NAREEN GARDENS

- INTRODUCTION
- COMMUNITY CONSULTATION UPDATE
- KEY ISSUES:
 - EASTERN BOUNDARY INTERFACE
 - INTERNAL SITE AMENITY
 - SOUTHERN BOUNDARY INTERFACE
 - OVERALL COMPATIBILITY & CHARACTER
- COMMENTS / DISCUSSION

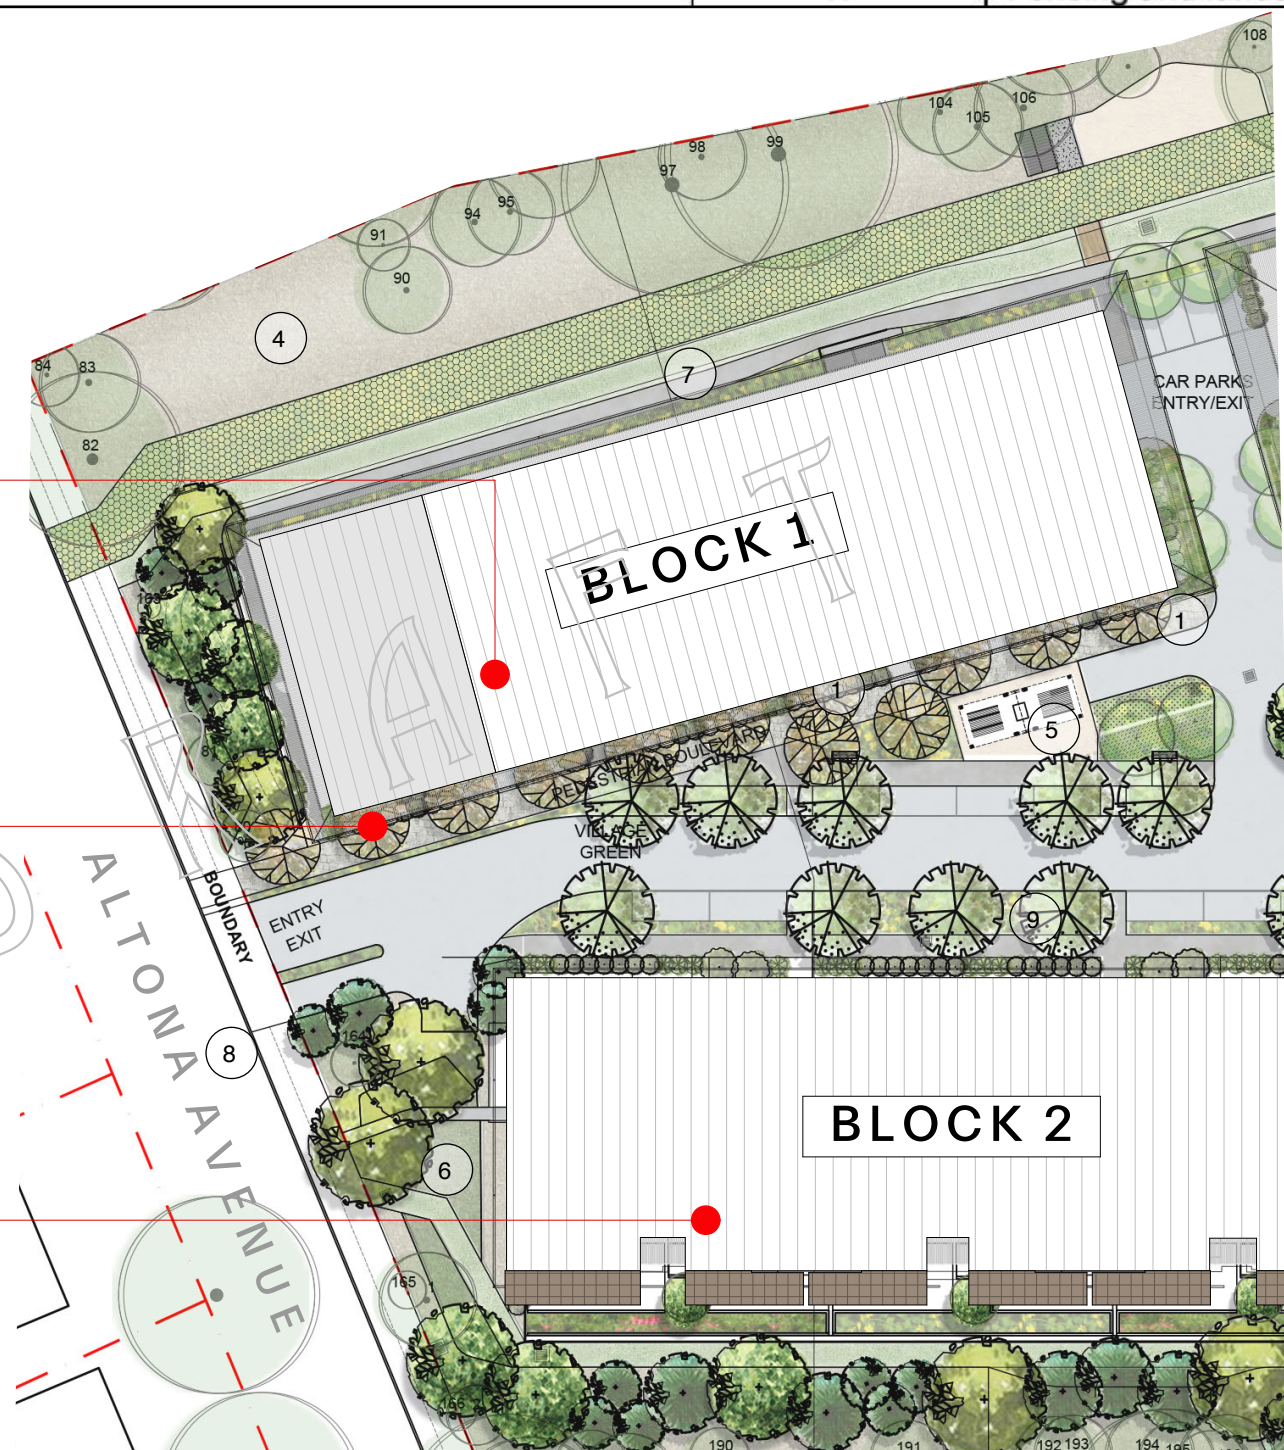
Southern Boundary Interface	7	Character and Scale – bulk and scale, transition from adjoining residences
	17	Fencing and landscaping treatments to Altona elevation

RFI # 7
BLOCK 1 UPPER LEVEL SET
BACK 20M FROM
BOUNDARY TO REDUCE
BULK & SCALE

RFI # 17
NO FENCING, RETAINED &
ENHANCED
LANDSCAPING TO
ALTONA, ADDITION OF
STREET FOOTPATH

RFI # 7
BLOCK 2 UPPER LEVEL
REMOVED TO REDUCE
BULK & SCALE

PREVIOUS DA SITE PLAN

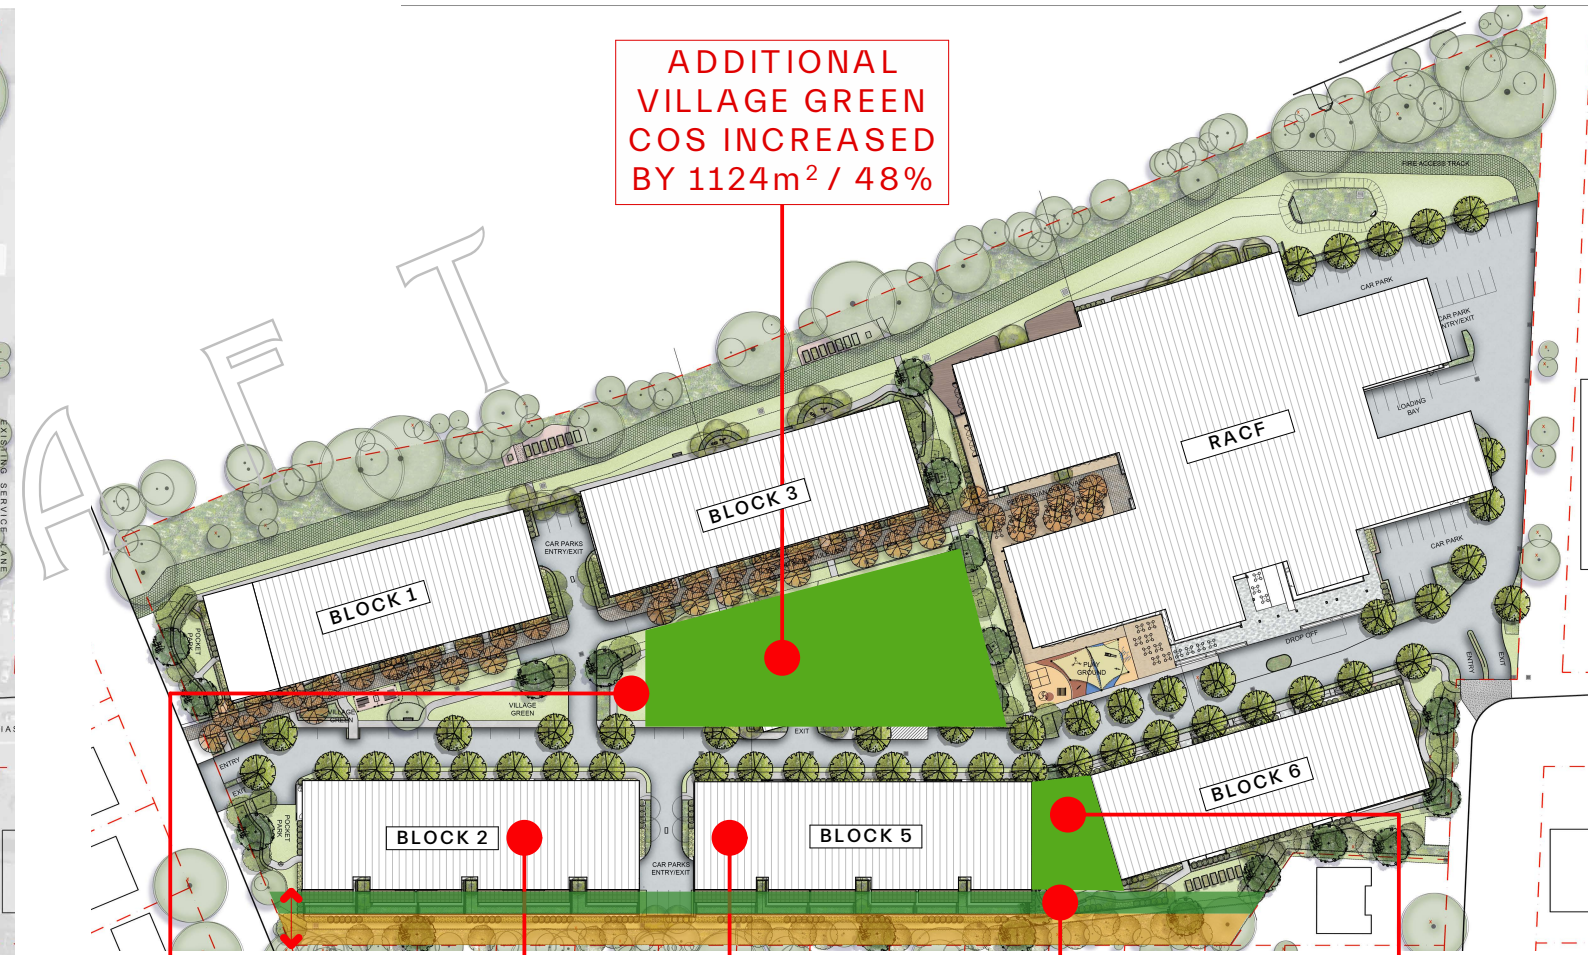
11	Wayfinding and Identity - Building 3 is hidden and does not appear to have its own identity and street address
18	Visual Privacy and Building Separation – 5 instances of noncompliance with minimum building separation
19	Communal Open Space – Require 25% of site area, solar to open space, provide a centrally located communal open space
21	Solar Access – increase apartments solar access by increasing building separation, consider removing Block 4
22	Block 4 – consider removal of block 4 to 1. improve separation distance of all buildings 2. provide a central communal open space 3. provide Blocks 1 and 3 with their own identity and address 4. allow greater setback from eastern boundary of Blocks 2 and 5

6M SETBACK

AMENDED DA SITE PLAN

13.6M SETBACK

HEIGHT REDUCTION AND
OVERALL DENSITY &
YIELD REDUCTION BY 18%
/ 42 APARTMENTS

HEIGHT REDUCTION OF
3.3M TO BLOCKS 2 & 5
(REDUCTION OF A FULL
STOREY)

7.6M (13.6M+
TOTAL)
ADDITIONAL
APARTMENT
SETBACK TO
EASTERN
BOUNDARY

INCREASED
COS
